## **RE: Allen Solar, LLC - Preliminary Minor Site Plan Review Application Follow Up Submittal**

On behalf of our client Allen Solar, LLC attached are revised plans to address comments made during the October 11, 2023 Planning Board meeting, the engineering review memorandum dated October 2, 2023, the Raymond Fire & Rescue plan review memo dated September 6, 2023 and subsequent emails and meetings with the Raymond Fire & Rescue. Review comments, resulting revisions, and request of the board are summarized below.

# Allen Solar Power, LLC. Roosevelt Trail Raymond, Maine

**Proposed Condition Site Plan**  
& Erosion / Sedimentation Control Plan

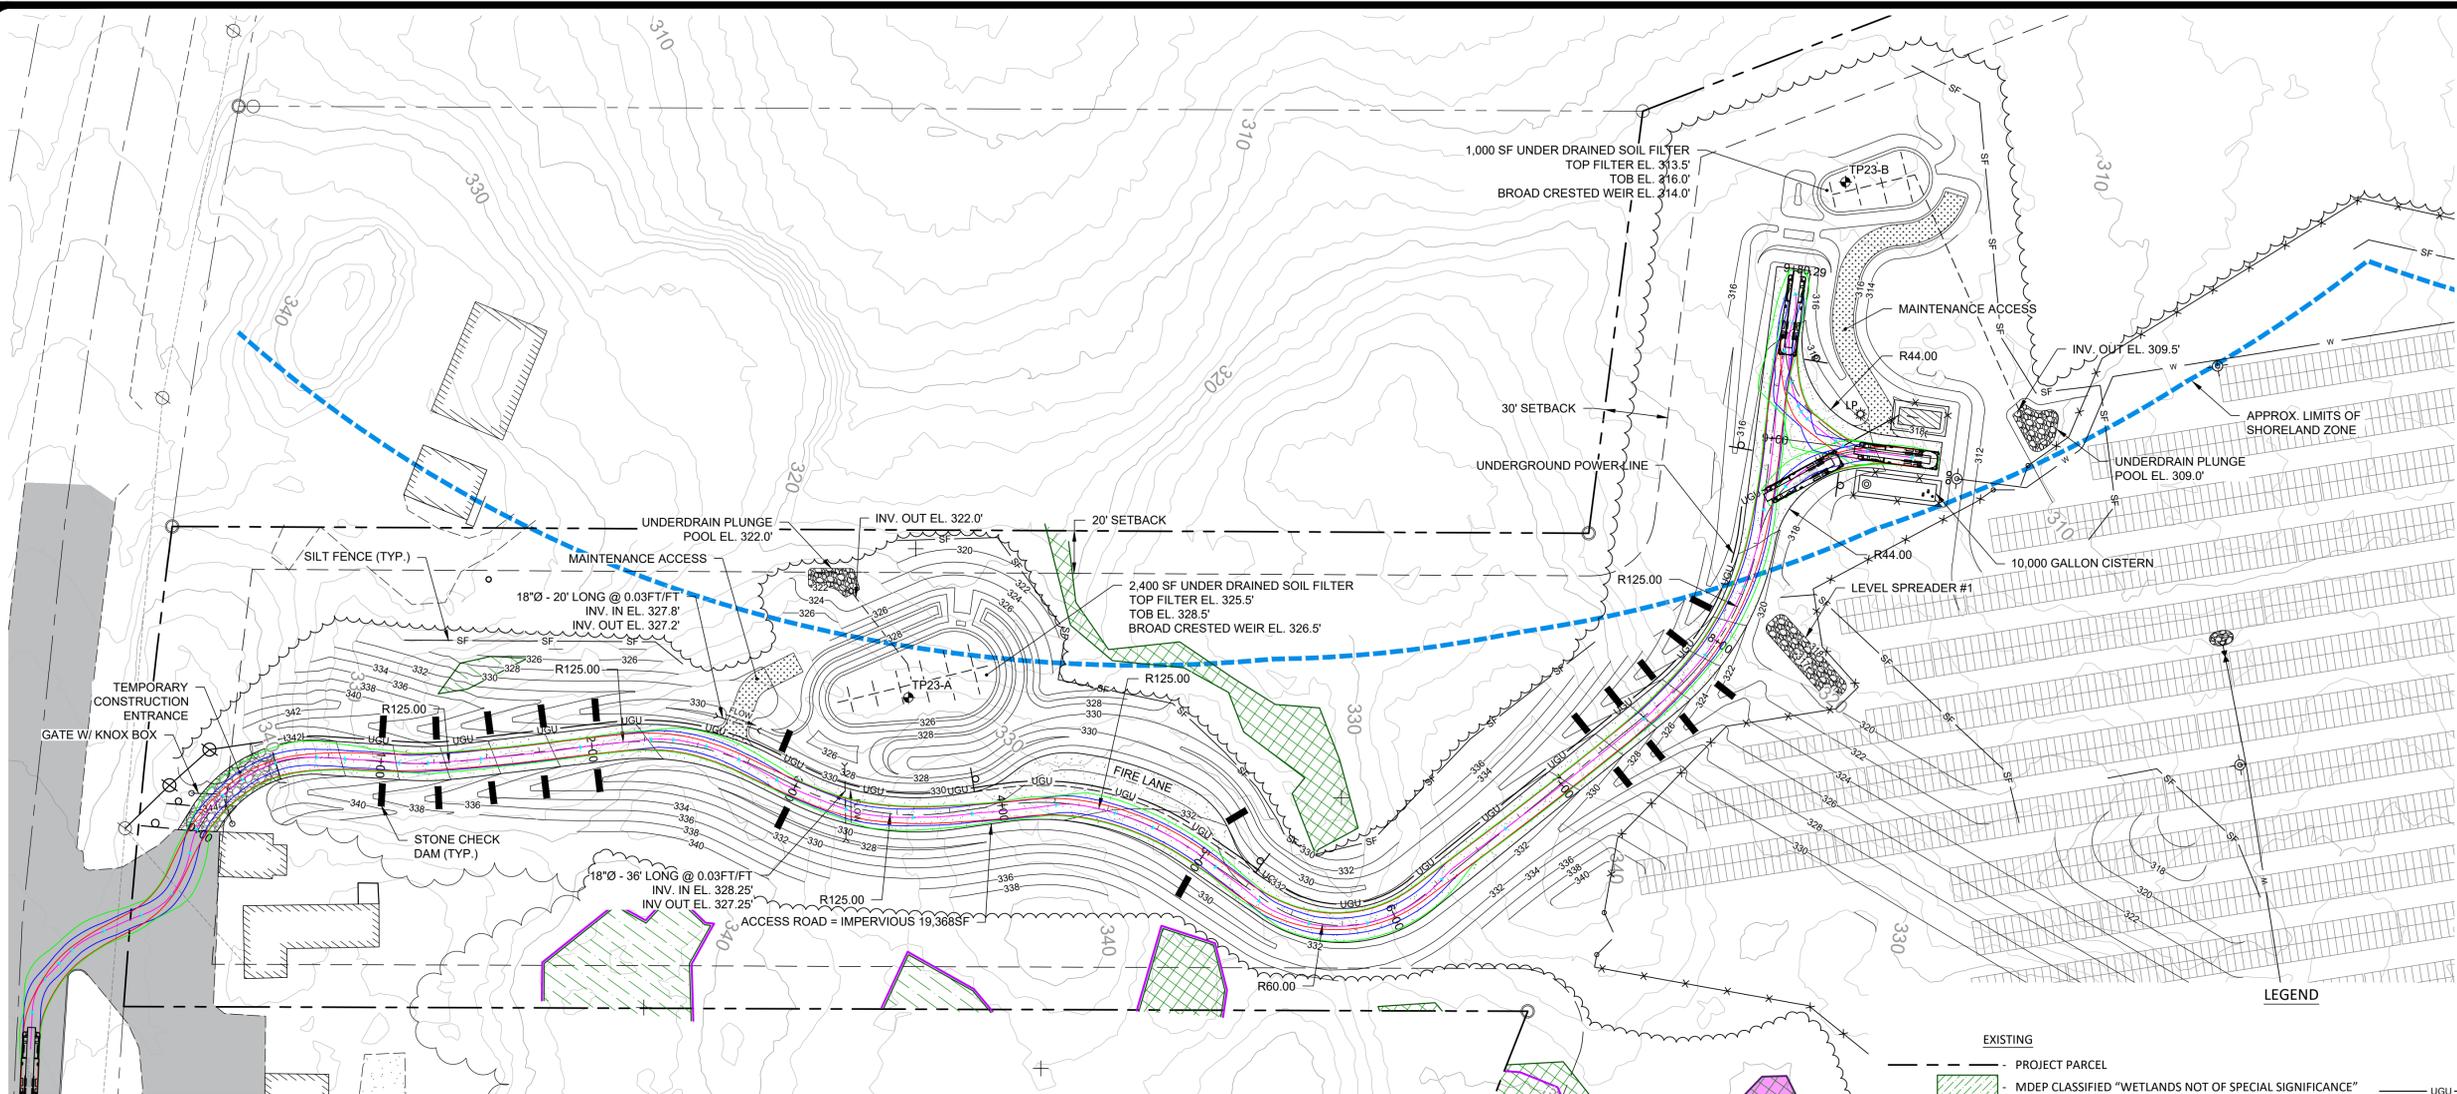
2. *The Raymond Fire & Rescue requested that the access road gate to the project be moved closer to Roosevelt Trail. The site plan has been revised to accommodate this request.*

4. *The fire & rescue department requested that a 16' x 80' bypass be provided if two trucks meet on the access drive. The site plan and access road plan/profile plan have been revised to include the bypass requested.*

6. *The planning/engineering department indicated that the design should include an access drive to each of the stormwater soil filters.* The site plan has been revised to include an access drive to each of the soil filters.

Project perimeter fence and tree line adjusted to minimize impact to Shore Land Zone.	Modifications to access road and solar array regarding the components for fire protection.	Revision Description
A	B	No.

**Fire Protection Site Plan & Details**  
 Mainely Solar, LLC  
 143 Highland Shores Road  
 Casco, Maine

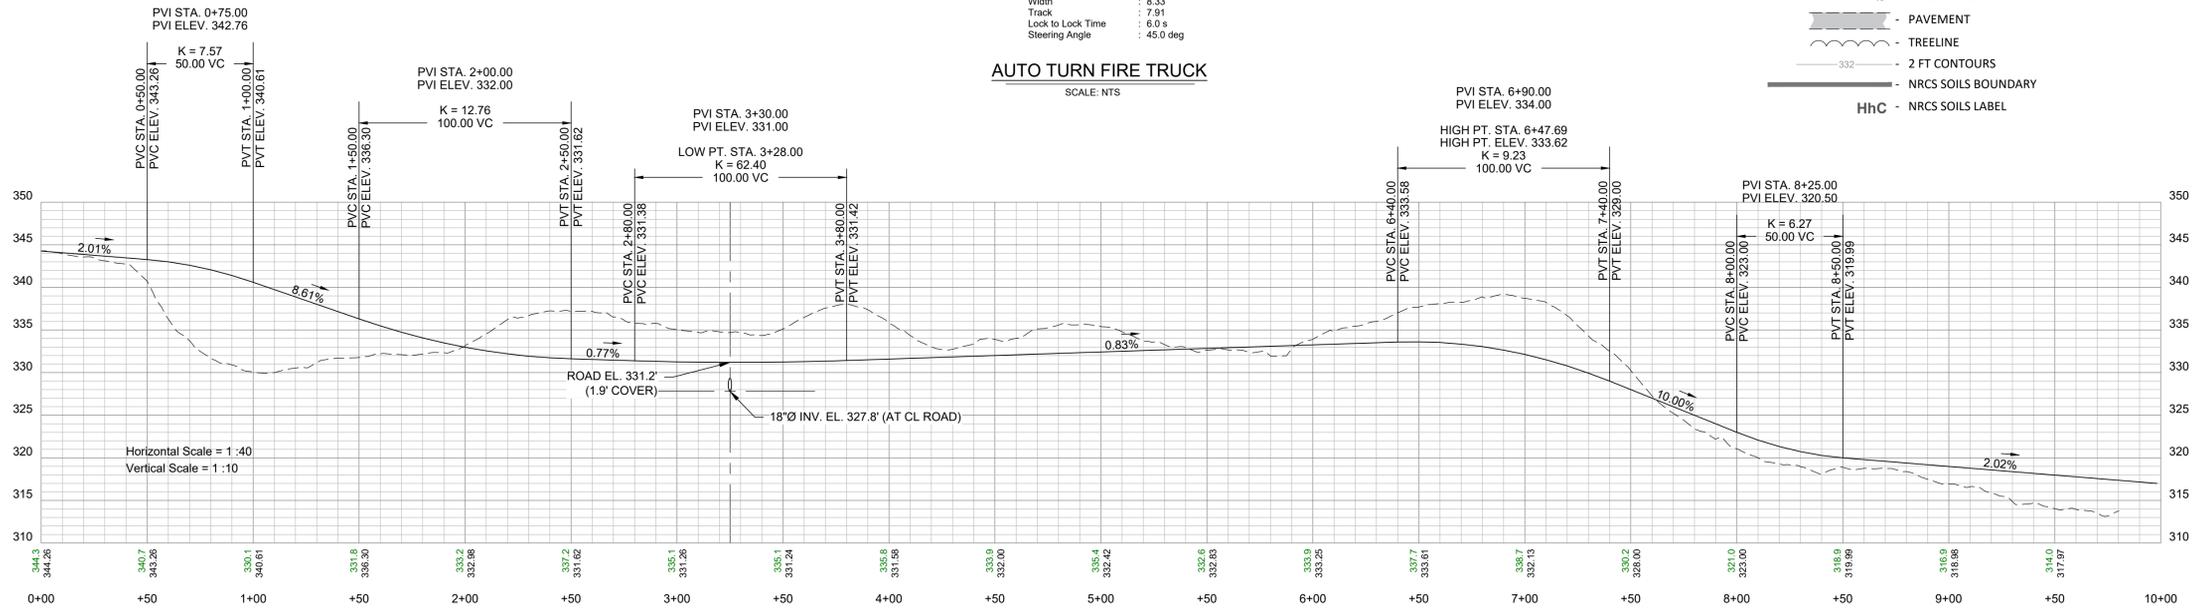
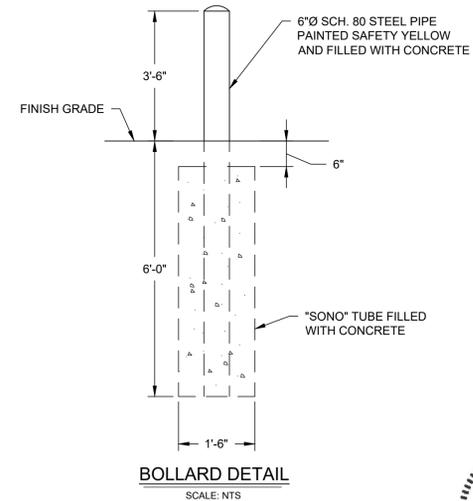
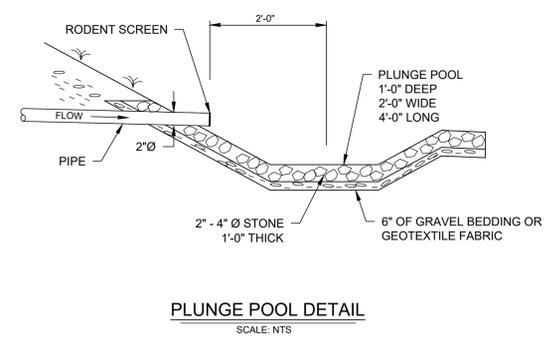
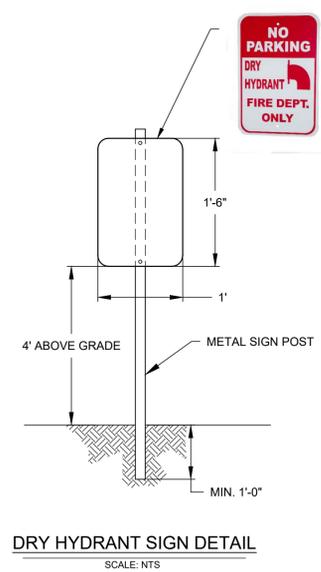
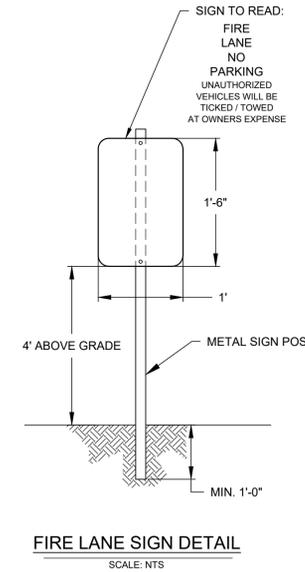
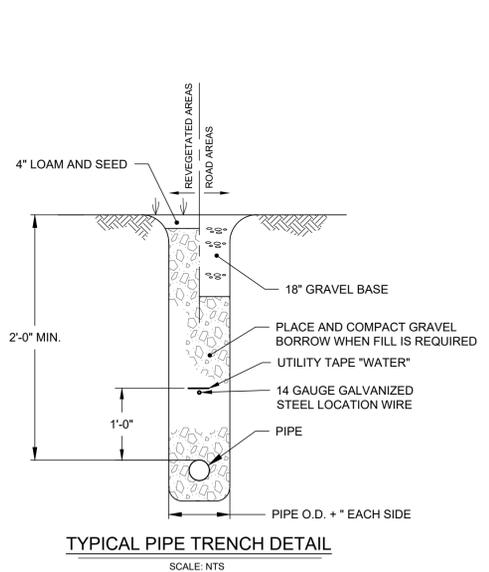
3. *In lieu of requiring a road to the north end of the project, the fire & rescue department requested that a dry stand pipe system would be acceptable. The stand pipe system would allow firefighters to have hose connections within the solar field. The system should allow a pumper truck to be positioned adjacent to a 10,000 gallon cistern, connected to the dry hydrant and pump water through the dry stand pipe system to hose connections within the solar field. Since the meeting, Sebago Solar and Acheron Engineering has met with the fire department and reviewed the specific requirements for the cistern and dry standpipe system. Based on this meeting a cistern and dry standpipe system for the project has been included on the site plan and a new plan sheet titled "Fire Protection Site Plan & Details" has been included in this submission.*

6. The fire standpipe system has been added to the plans, including access gates providing RFRD accessibility to the fire standpipe outlets.
7. A note has been added noting that the fire standpipe system is proposed in lieu of providing fire lane access around the entire site to meet NFPA requirements.

- 11. THE FIRE STANDPIPE SYSTEM SHOWN ON THE PLAN IS IN LIEU OF PROVIDING FIRE LANE ACCESS AROUND THE ENTIRE SITE TO MEET NPFA REQUIREMENTS.
  - 12. THE OPERATIONAL READINESS OF THE FIRE CISTERN, COMPONENTS, AND STANDPIPE SYSTEM INCLUDING REPAIRS AND REPLACEMENT, IS THE RESPONSIBILITY OF THE OWNER OF THE SOLAR FACILITY.

**LEVEL LIP SPREADER DETAIL**  
NOT TO SCALE

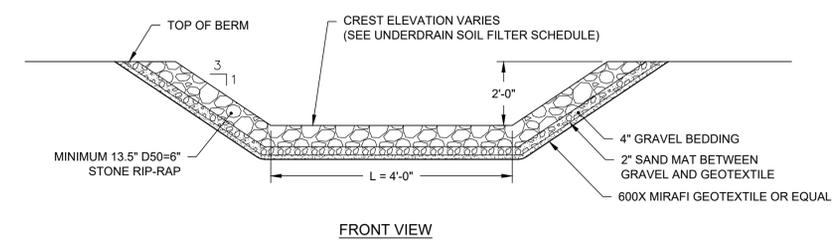
3. *It was requested that the grading under the solar farm be reviewed to make sure that there are no additional areas of channelized flow.* The location of the road and the grading under the solar farm does result in channelized flow. However, the design includes a level spreader to convert the channelized flow to sheet flow.
